ADDENDUM NO. 1

**ARCADIA HIGH SCHOOL
LOCKER ROOM ALTERATION
ARCADIA UNIFIED SCHOOL DISTRICT**

tBP/ARCHITECTURE
4611 Teller Avenue
Newport Beach, CA 92660
949-673-0300

This Addendum forms a part of the Contract Documents and modifies the original Bidding Drawings dated August 15, 2024, and Specifications dated July 2024. Acknowledge receipt of this Addendum in space provided on the Bid Form. Failure to acknowledge may subject Bidder to disqualification.

C2.00

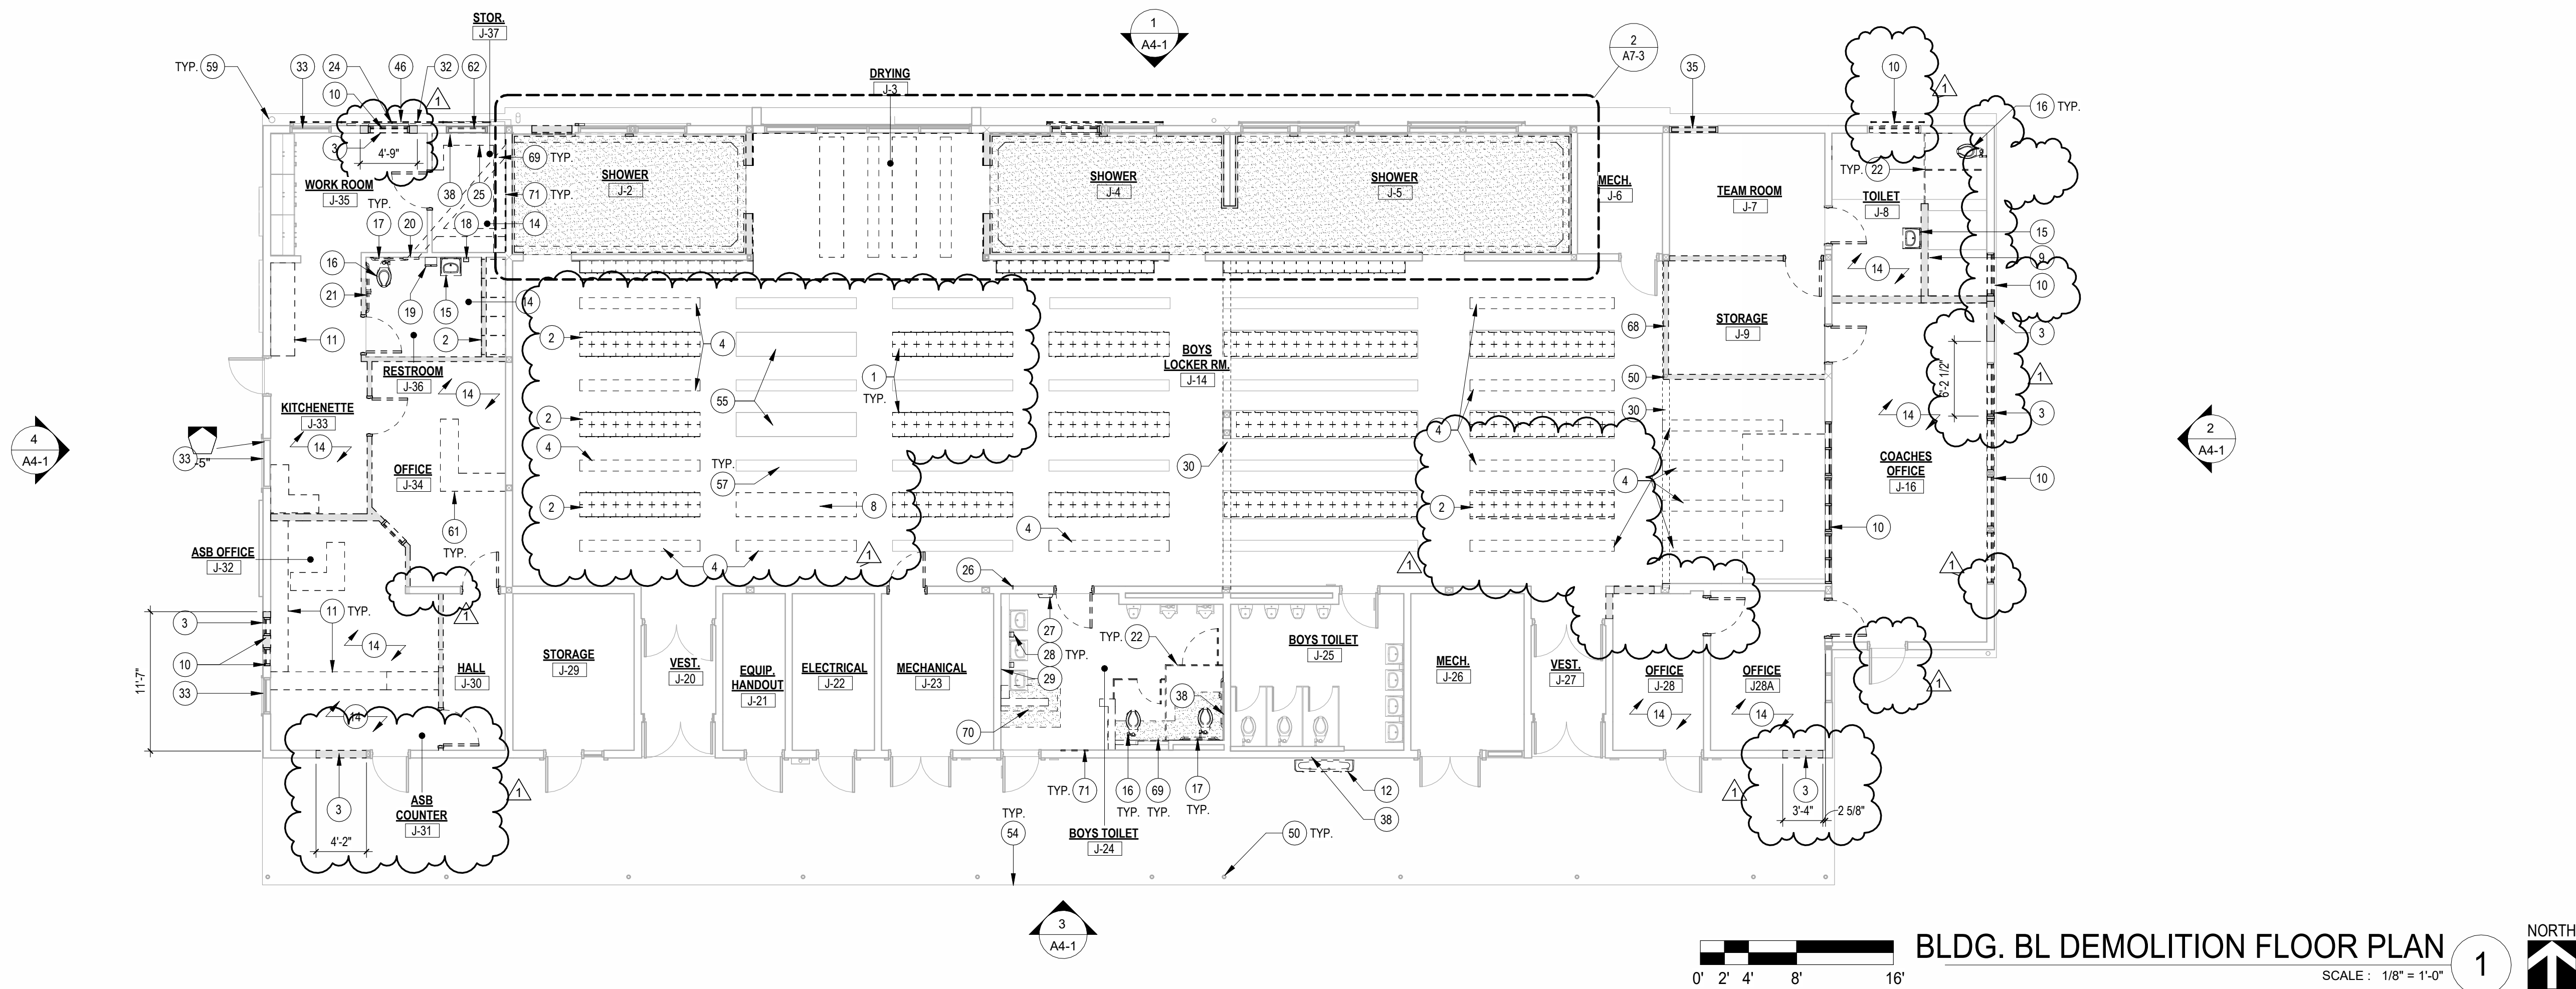
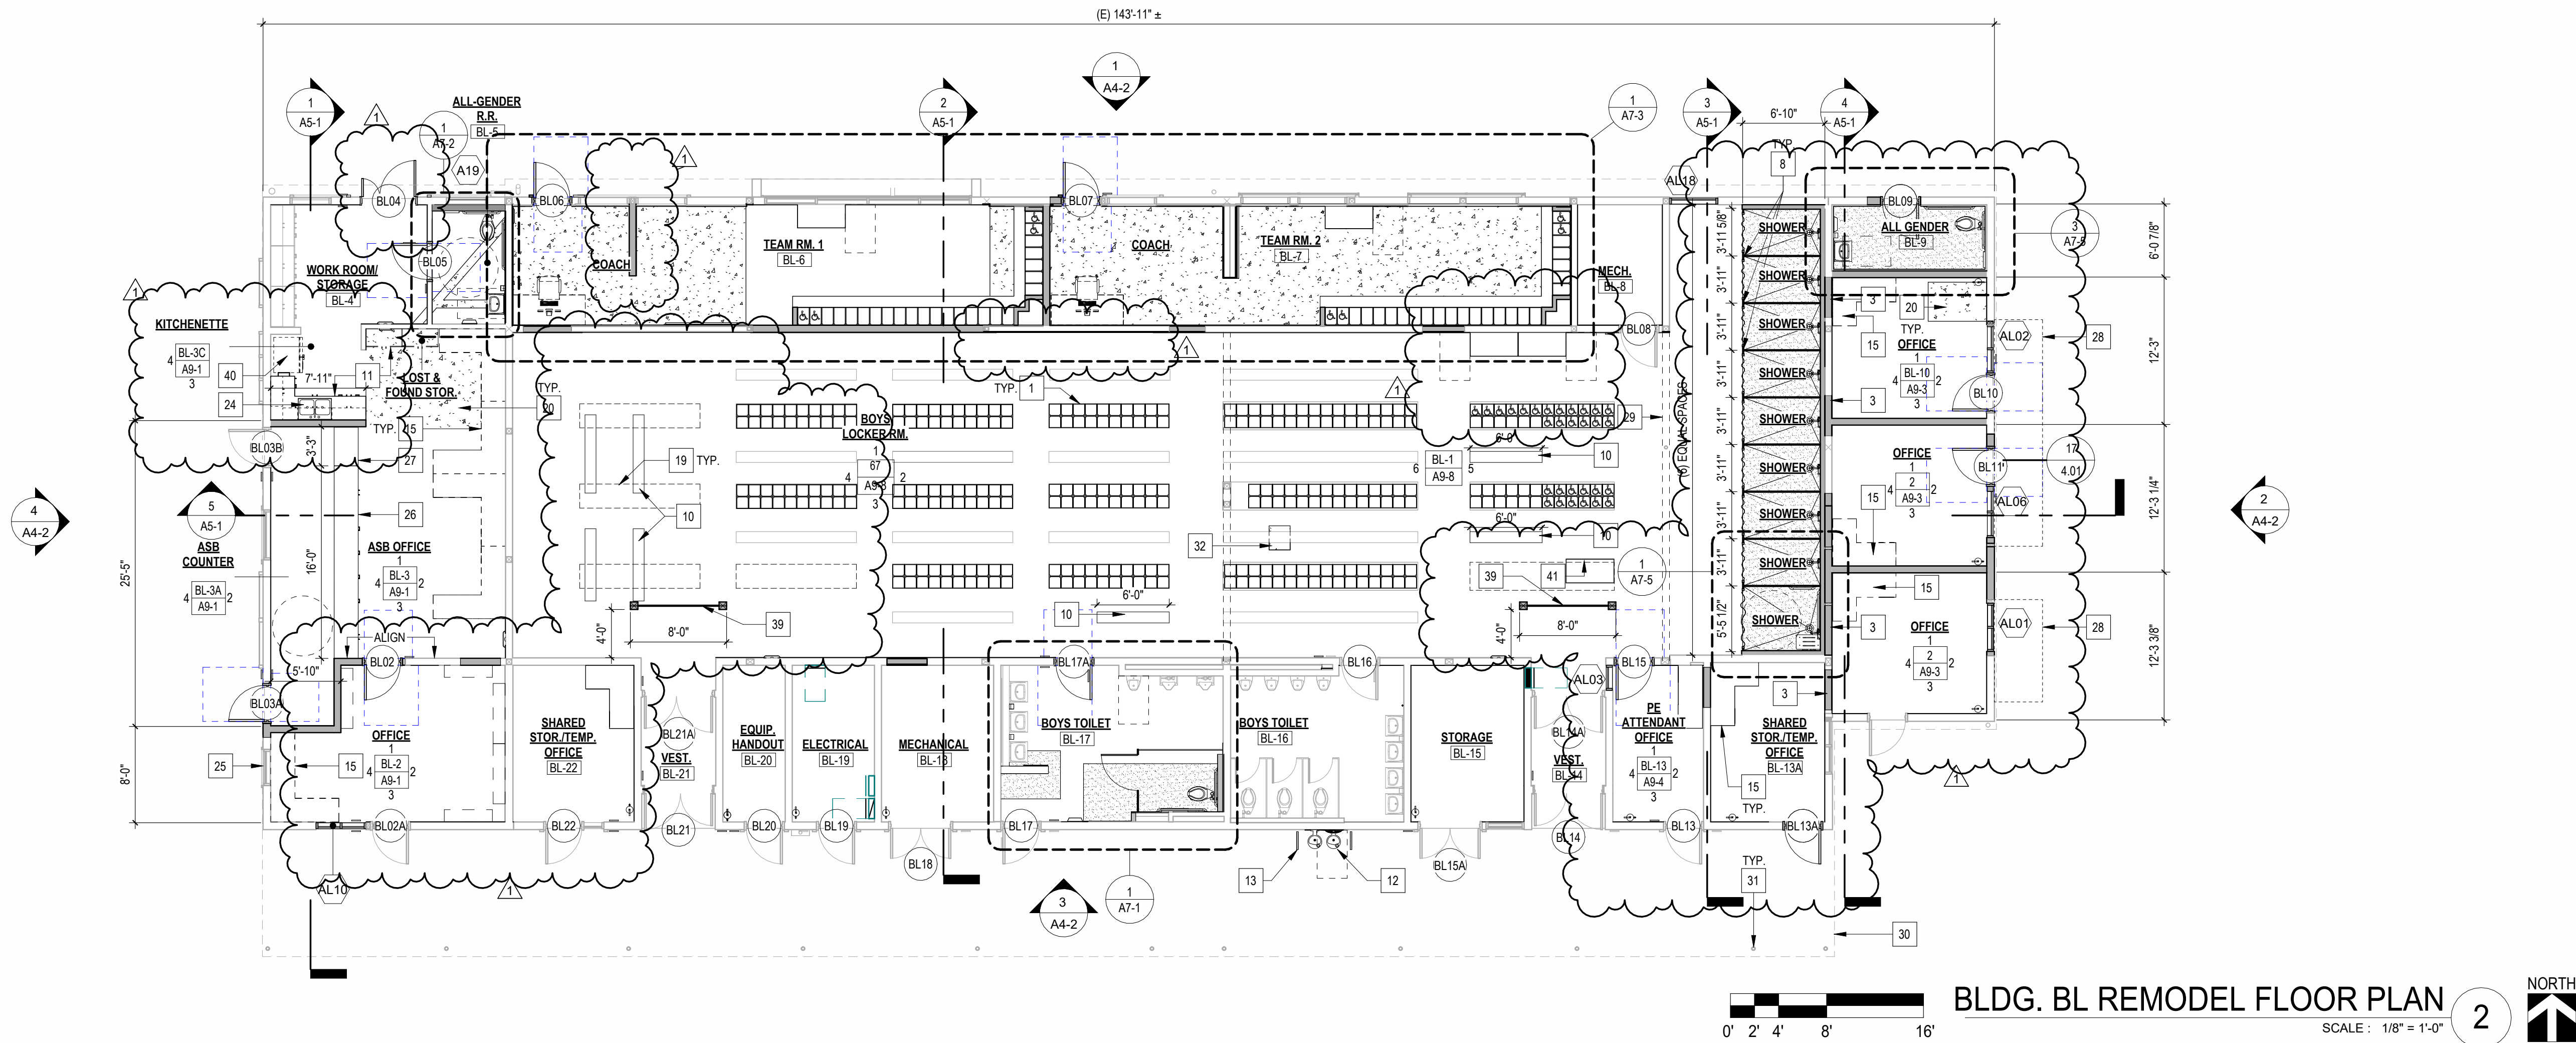
2. SHEET C2.00 – GRADING PLAN
Replace full size sheet drawing **C2.00** in its entirety, issued with this addendum.
Change includes:
 - a. Remove concrete curb on both sides of concrete walkway at north of Building BL.
